814-003-14

ADDENDUM NO. 1

PROPOSAL FOR CONTRACT FOR
Lincoln Christian School
HVAC Upgrades
Lincoln, Nebraska

3 GAS RISER DIAGRAM
 SCALE: NO SCALE

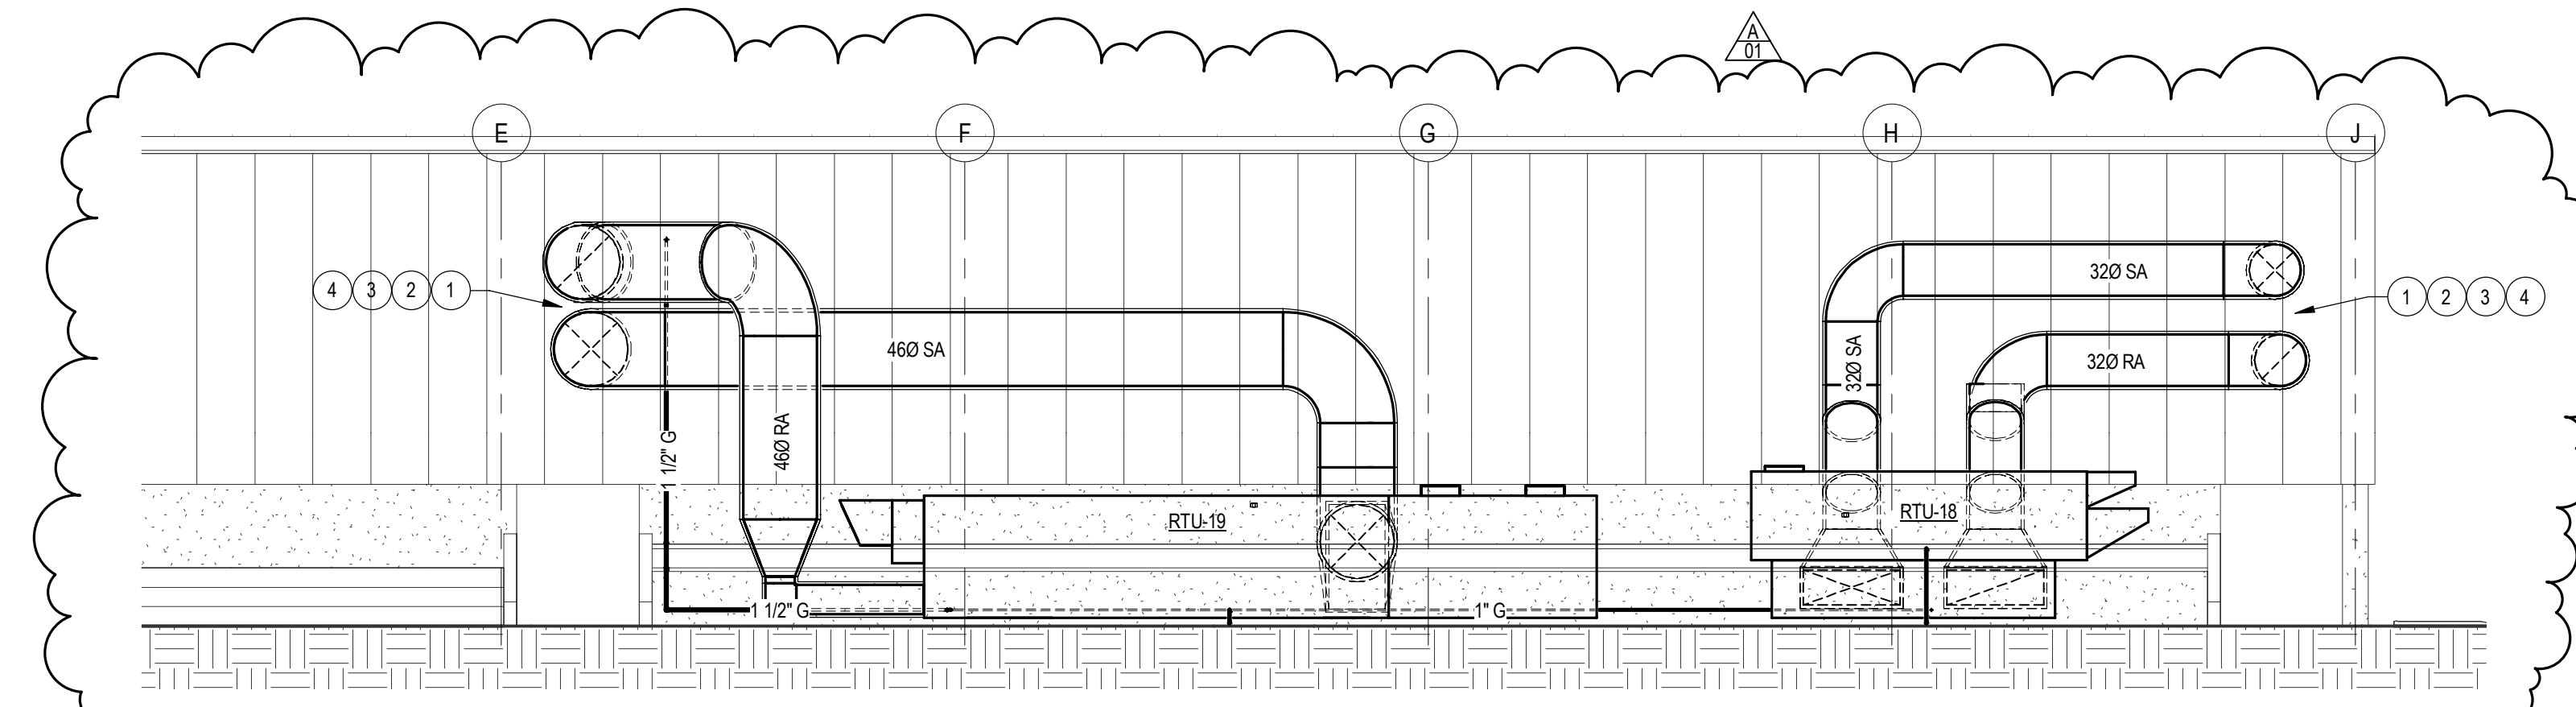
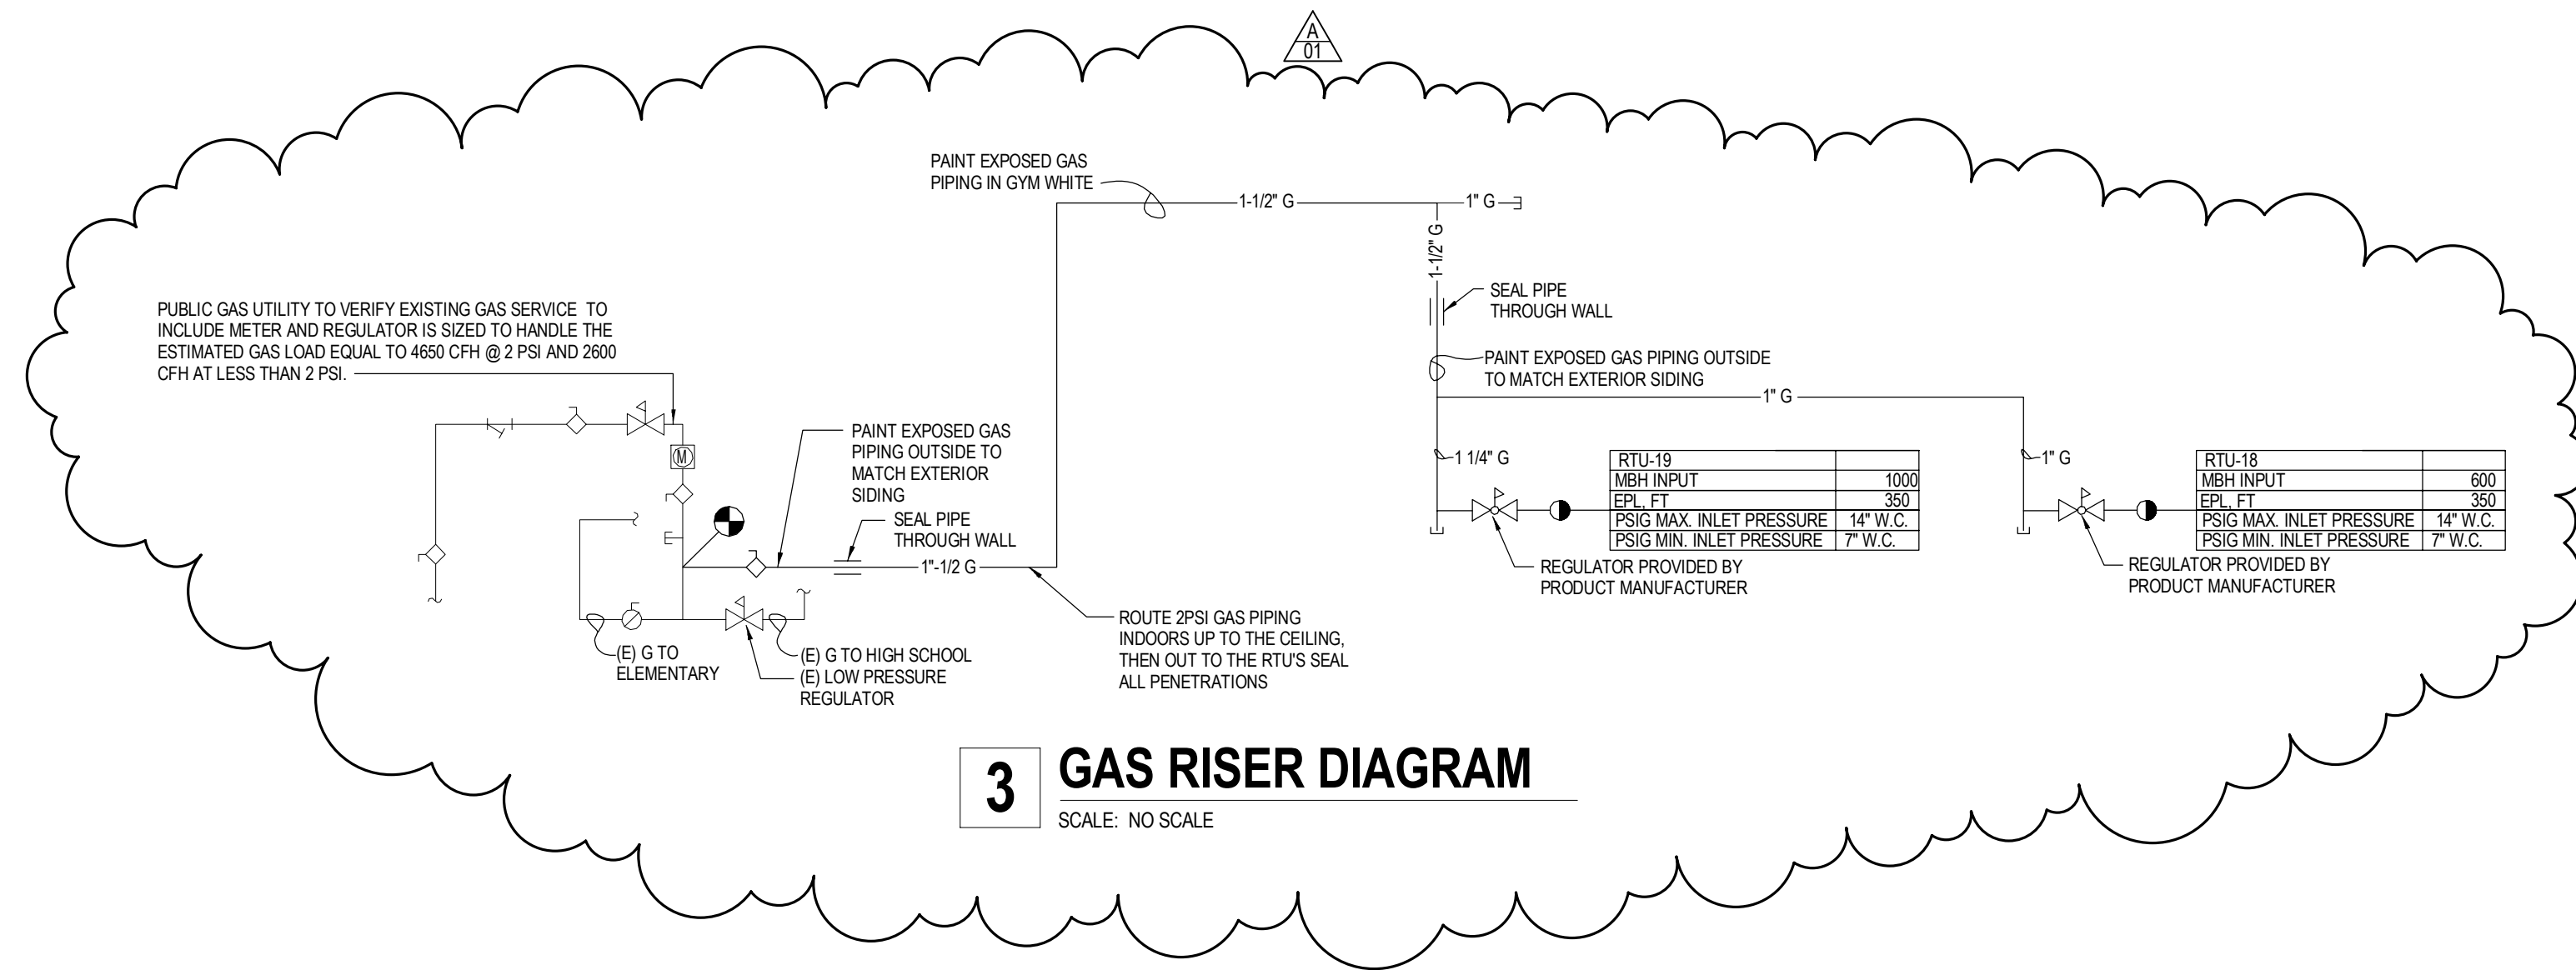
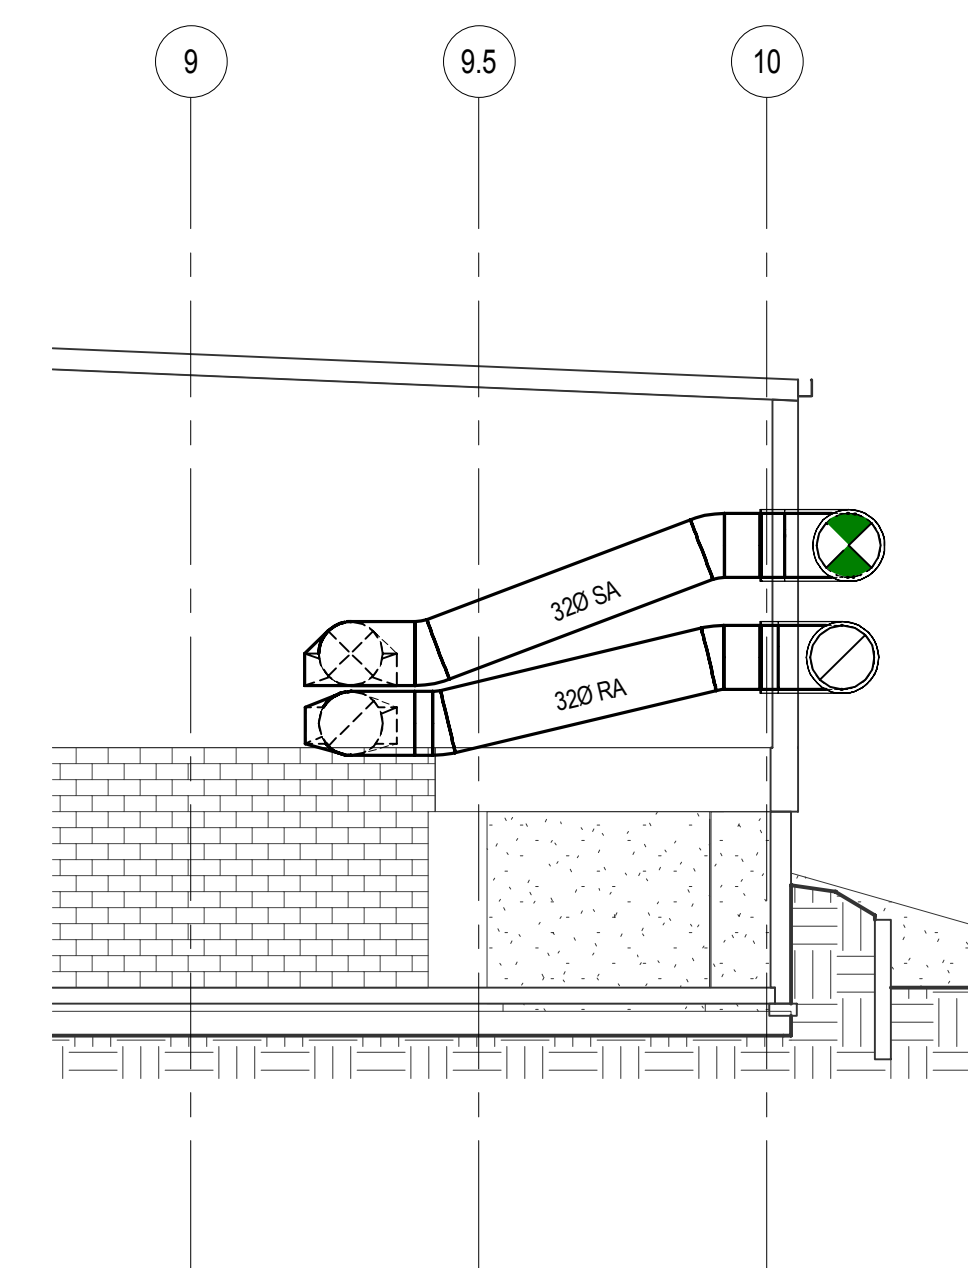
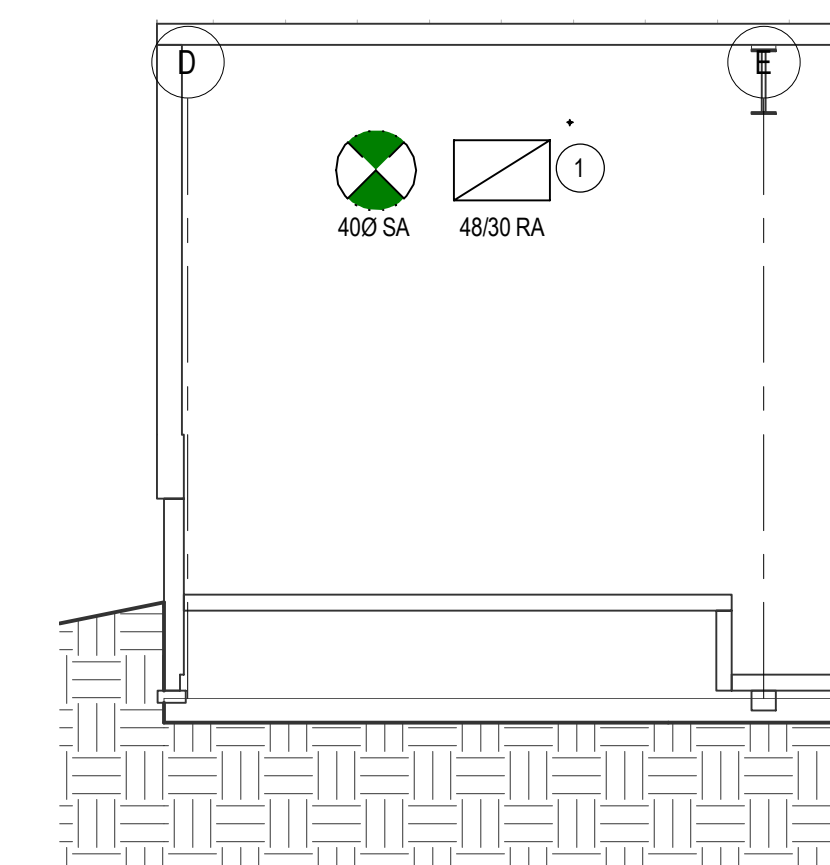
M2.01 has been re-issued in its entirety, see changes to the gas riser, and sections.
